**Draft Report to the
City of Portsmouth, New Hampshire
On the
Wastewater Master Plan
Value Engineering Review**

March 2, 2010

Subject: City of Portsmouth Wastewater Master Plan
Draft Value Engineering Study Report

CITY OF PORTSMOUTH, NH WASTEWATER MASTER PLAN VALUE ENGINEERING STUDY REPORT

SCENARIO 1A: PEIRCE ISLAND WASTEWATER TREATMENT FACILITY

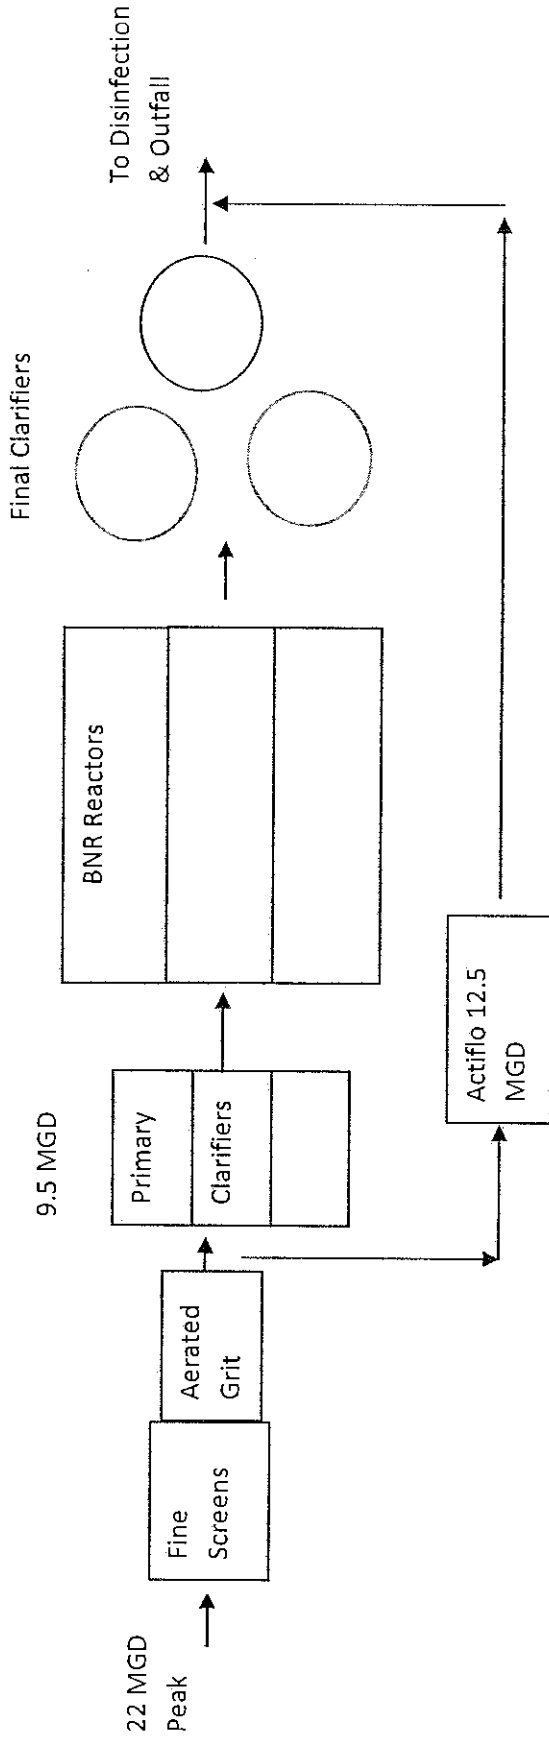
- Reduce the size of the treatment facilities for sanitary wastewater flows from 8.9 mgd to 7.5 mgd for year 2030 with 6.3 mgd being treated at the PI WWTF and 1.2 mgd being treated at the PIT WWTF. Continue to treat wet weather flows at the PI WWTF
- Design facilities for a TN = 8 mg/L at PI and TN = 5 mg/L at PIT
- At the PI WWTF use the following treatment process for secondary treatment in lieu of SBRs
 - Fine screens (1/4 inch)
 - Aerated grit removal
 - New rectangular clarifiers (3)
 - BNR reactors using the MLE process with blower building and sludge pump station
 - Final clarifiers (convert two existing primary clarifiers to secondary clarifiers and construct one new secondary clarifier)
 - Actiflo type process for wet weather flows
 - Biosolids processing same as existing Scenario 1
- Future TN polishing at the PI WWTF would require the addition of an MBBR or BAF reactor

- Debottleneck force main at Parrott Avenue
- Store 2.9 MG of wet weather flows in a precast concrete box culvert system (20 rows of 10-ft. by 10-ft. x 200-ft. long concrete boxes) located in the parking lot where the proposed cast-in-place concrete tank is currently located. See attached article about the Davis Brook CSO Storage Facility in Bangor, Maine in Appendix D.

SCENARIO 3A
PEASE TRADEPORT WASTEWATER TREATMENT FACILITY
PROCESS FLOW DIAGRAM

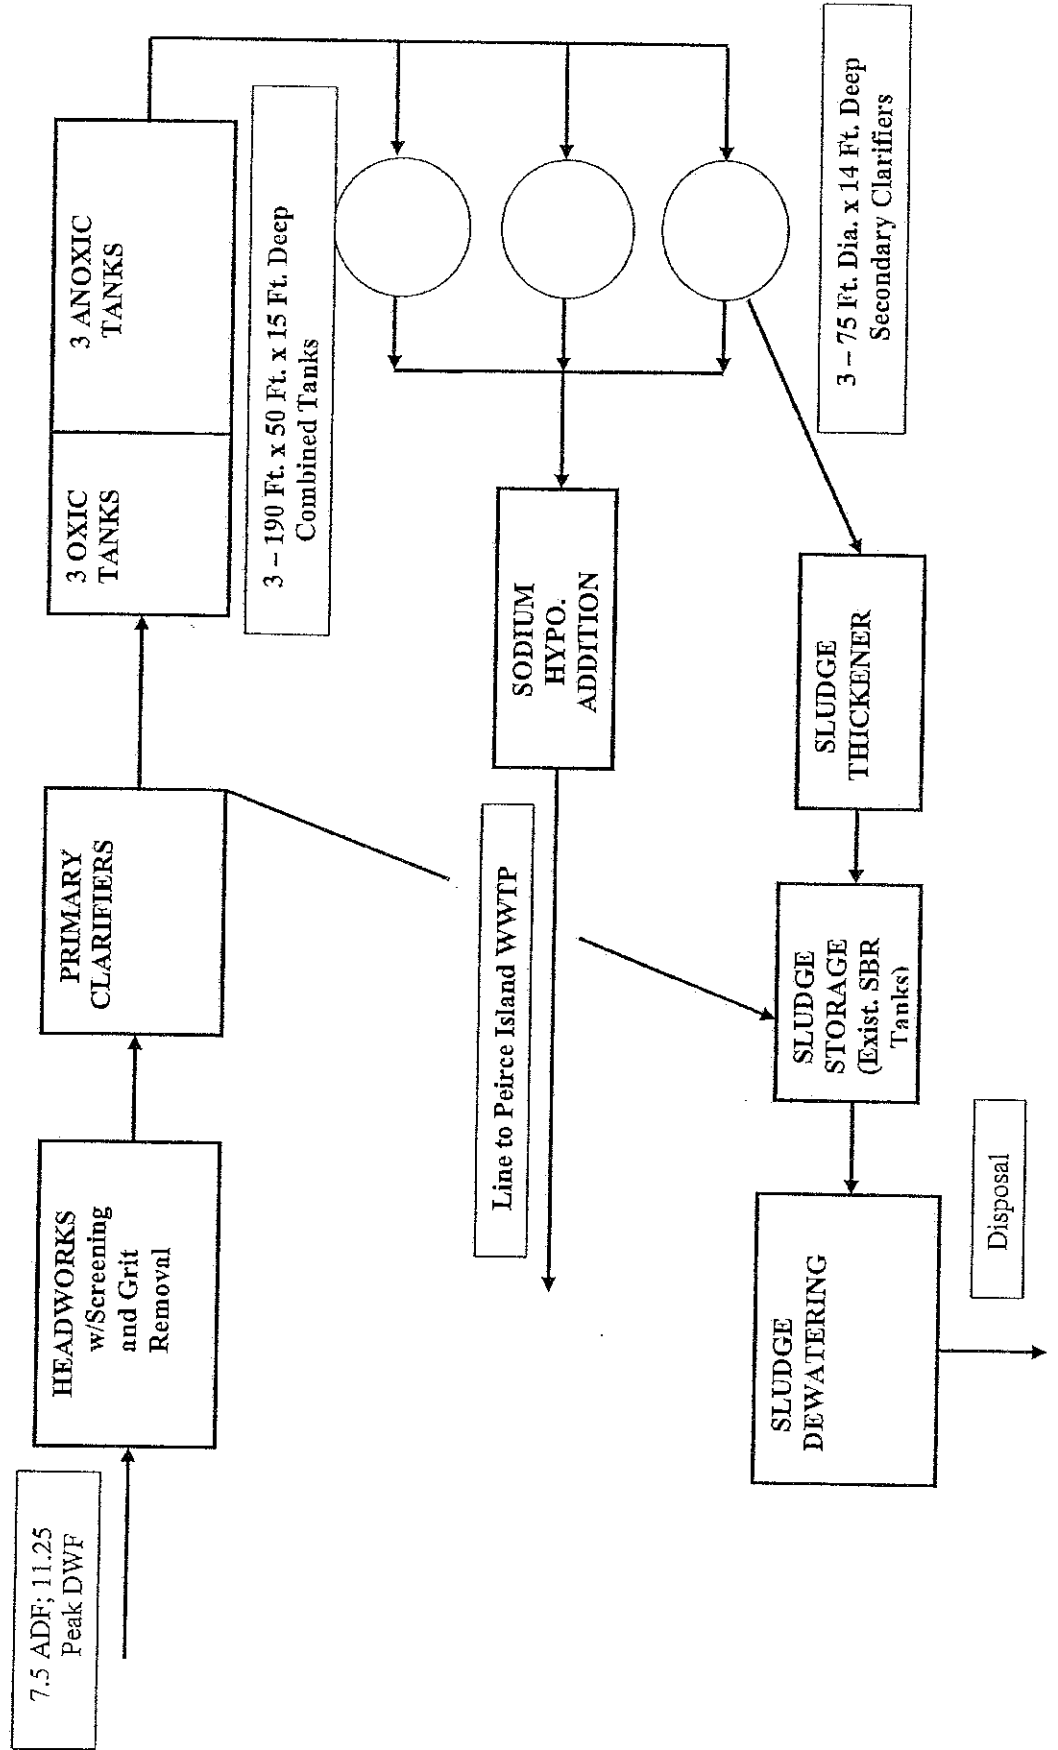
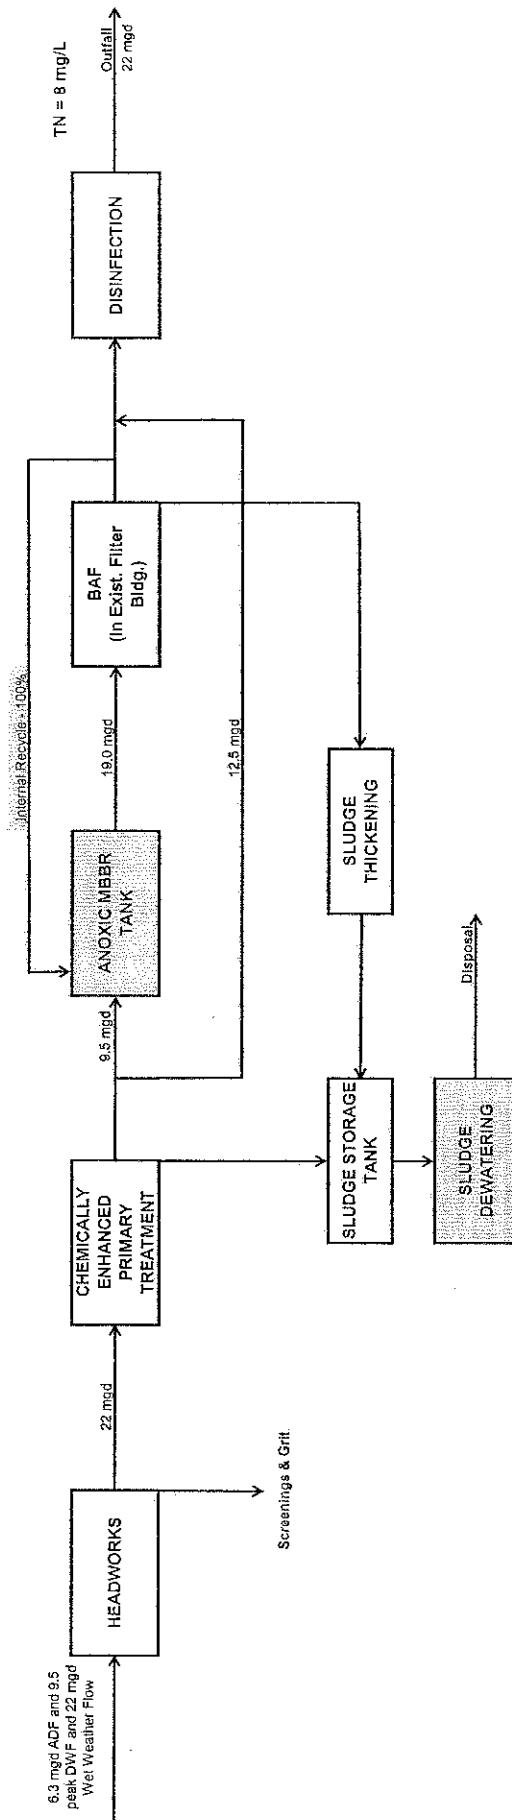
- Reduce the size of the treatment facilities for sanitary wastewater flows from 8.9 mgd to 7.5 mgd for year 2030 with all flows being treated at the PIT WWTF and all wet weather flows being treated at the PI WWTF

- Design the facilities for a TN = 8 mg/l (since with the increase in the PIT flow, the effluent must be conveyed back to the PI outfall for discharge). Discharge all effluent at the PI WWTF outfall by installing a new pump station and effluent discharge line from the PIT WWTF to the PI WWTF via the Deer Street Pump Station

- Use a secondary treatment process consisting of primary clarifiers, influent pump station, reactor with anoxic and aerobic zones (three combined tanks 190 ft. long, 50 ft. wide and 15 ft. deep with common walls), secondary clarifiers (three tanks 75 ft. in diameter with a 14 ft. side water depth), sludge pump station with 5 RAS pumps and 3 WAS pumps 50 ft. by 50 ft., and ultraviolet disinfection. Convert the existing SBR tanks to sludge holding tanks. Provide sludge thickening and dewatering.

VALUE ENGINEERING SCENARIO
PEIRCE ISLAND WASTEWATER TREATMENT FACILITY
PROCESS FLOW DIAGRAM

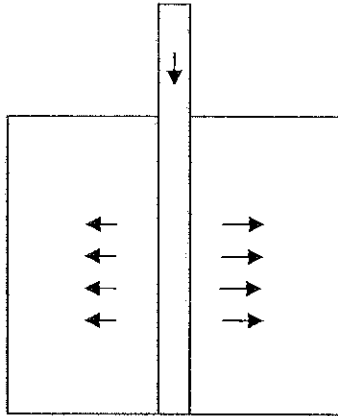
- To achieve a TN = 5 mg/L in the future, add an anoxic MBBR or BAF in the existing abandoned filter building. See Appendix B for Process Flow Diagram.
